Amendments to the Drawings:

REMARKS/ARGUMENTS

Appl. No. 10/808,625 Amdt. sent February 16, 2007

Reply to Office Action of August 18, 2006

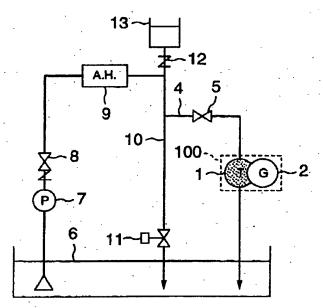
Objections to the Drawings

Applicants thank the Examiner for pointing out the informality in the drawings. Figure 11 has been labeled as prior art in accordance with MPEP §6.08.2(g). This amendment is believed to overcome the objection to the drawings.

The attached sheet of drawings includes changes to Fig. 11. This sheet, which includes Fig. 11 replaces the original sheet including Fig. 11.

Here, Satoh fails to teach, either explicitly or impliedly, a pressure sustaining valve disposed in a return pipe line and configured to open and close in response to pressure variations in the return pipe line. Figure 9 of Satoh, relied on by the examiner, is reproduced below:

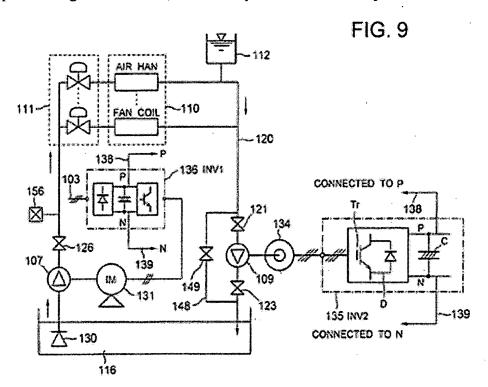
Satoh discloses a method for collecting unused energy in a building through waterwheel electric power generation. Valve 149 and pipe-segment 148, which are cited by Examiner and more clearly illustrated in Fig. 6 as reference numbers 29 and 29a, respectively, are used in order to bypass valves before and after the waterwheel 109 (See paragraph [0054]). In addition, pressure sensors are located at the inlet side of the water wheel and the outlet side of the water wheel, but not at bypass valve 29 or in bypass pipe-segment 29a (See paragraph [0054]). As such, bypass valve 29 is not configured to selectively adjust in response to varying water pressure because there are no pressure sensors located within bypass pipe 29a or at bypass valve

29. Furthermore, the type of operation described in Satoh requires additional sensors and processing, thereby increasing installation and operation costs. In short, the Satoh reference fails to teach, either explicitly or impliedly, a pressure sustaining valve disposed in the return pipeline and configured to selectively open and close depending on water pressure in the pipe, as substantially recited in independent claims 1 and 2.
